PLANNING NMA-CHANGE LIST		
ID	Proposed Changes to plans that are 'Non Material'	Reason for 'Amendment'
A	Changes to Common stair towards compliance for general access where a clear landing needs to be provided and to accommodate smoke control. Circulation area and internal doorway to stairs rearranged to adapt corridor aisle. Stairs, structurally stacked for construction leading towards the corridor or lobby next to the stair being provided with a smoke vent and a store area provision on ground level. Rearrangement in plan due to the above visible on the Northwest facade. Window openings, adapted to suit mentioned changes/rearrangement.	Compliance towards Building Regulations, Part-K-Protection from falling, collision and impact and Part-B-Fire safety
B	Changes to Communal lifts and stairs towards compliance for firefighting where a firefighting shaft is required as the building is over 18m and to accommodate smoke control and building services. Circulation area internal doorway to stairs and clear landing for lifts rearranged to adapt corridor aisle. Stairs, structurally stacked for construction leading towards a vertical smoke shaft that opens at roof level with rationalised comm

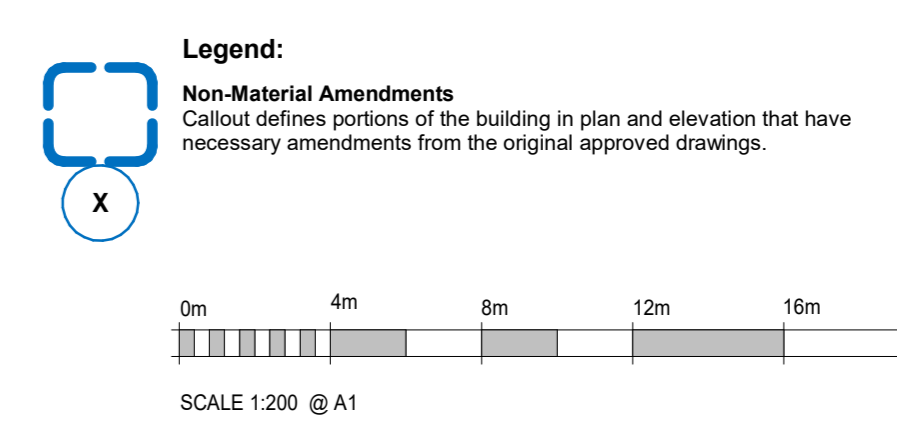
C	Changes to communal roof gardens (landscaping) including change of barrier type (railing) from glazed balustrade to counterbalance metal railing.	To contribute positively towards biodiversity via balance of soft and hard landscaping schemes including provisions for bird and bat boxes, whilst maintaining overall uniformity for railing type.
D	Removal of photovoltaic (PV) cells on the roof	PV was not required as Part L requirement was met using Exhaust Air Heat Pumps.
E	Relocation of Substation and provision for Generator in allocated space.	Provision for separate secluded area for generator
F	Changes to provide new location for UKPN Substation	Provision for future relocation for UKPN Substation
G	Changes to ground level Cycle store to accommodate building services plant rooms including removal of two openings with rearrangement of the remainder openings.	Provision towards Building Services, Secondary LV switch room and Corris room.

H	Changes to ground level Bin store internal arrangement for secure access including removal of foyer and two openings, whilst adding double doors.	Provision towards secure access for Bin store
J	Removal of Cycle store area and Bin store area at ground level, including external door in cycle store area towards provision to accommodate building services plant room including clear vehicular access towards undercroft parking.	Provision towards Building Services, Primary LV switch room and vehicular access towards undercroft parking.
K	Changes to ground level facade including removal of two openings to accommodate communal letter boxes with rearrangement of the remainder openings with provision for accessibility.	Provision towards communal letter boxes
L	Removal of undercroft parking entrance/exit at ground level towards provision for Relocation/Retainment of existing UKPN Substation, whilst adding double doors as per change ID C-05.	Provision towards single point of entry/exit for undercroft parking and towards relocation/retainment of existing UKPN Substation mentioned in change ID-E.

M	Changes to ground and first floor level, Common stair for means of fire escape and to accommodate smoke control to circulation area. Circulation area and internal doorway to stairs rearranged to adapt corridor aisle. Stairs, moved away from corridor aisle leading towards provision for an external smoke vent at first floor level. Rearrangement in plan due to the above visible on the Northeast facade. Ground level escape door, adapted to suit mentioned changes/rearrangement.	Compliance towards Building Regulations, Part-B-Fire safety.
N	Changes to ground level Cycle room and adjacent Store to replace provision for Cycle store area as per change ID C-09 via consolidation. Rearrangement in plan due to the above visible on elevations.	Provision towards replacement of removed cycle store mentioned in change ID-J.
P	Changes to Communal lift and stairs towards compliance for general access where a clear landing needs to be provided and to accommodate smoke control and building services. Circulation area internal doorway to stairs and clear landing for lifts rearranged to adapt corridor aisle. Stairs, structurally stacked for construction leading towards covered and enclosed stair at roof fourth floor level with rationalised communal entrance/exit. Rearrangement in plan due to the above visible on elevations.	Compliance towards Building Regulations, Part-K-Protection from falling, collision and impact, Part-B-Fire safety and Provision for stair enclosed/walkway that is directly covered.

Q	Changes to ground level Bin store arrangement to replace Bin store as per change ID C-09 via consolidation and enlargement to provide building services plant room. Rearrangement in plan due to the above visible on elevations.	Provision towards replacement of removed Bin store mentioned in change ID-J and provision for BCW Tank room.
R	Changes to ground level openings, facade screens from circular pattern metal screens/vents to vertical extruded aluminium flats metal screen that match the railing type, including removal of one opening that clashes structural column on the comet way elevation.	To maintaining overall architectural uniformity and structural framing.
S	Removal of Green Wall as they do not comply with fire safety regulation 7(2).	Regulation 7(2), requires all residential blocks with top storey heights over 18m to have all materials which become part of an external wall or specified attachment (e.g., balconies) to achieve class A2-s1, d0 or class A1, except for materials which are exempt as per regulation 7(3). Additionally, membranes used as part of external wall construction above ground should achieve a minimum of class B-s3, d0.

T	Changes to storage area, rearrangement towards desired storage required.	Provision towards desired storage required.
U	Discrepancy error on Comet way elevation whereby two window openings depicted would not have been located on the fifth-floor level plan as these would intrude privacy for the bedrooms.	Discrepancy error
V	Removal of single window, recessed brick reveals on the Northeast elevation.	The recessed brick reveals is between two windows mostly on all elevations, whilst single windows mostly do not have such a detail. To maintain architectural uniformity, detail removed.
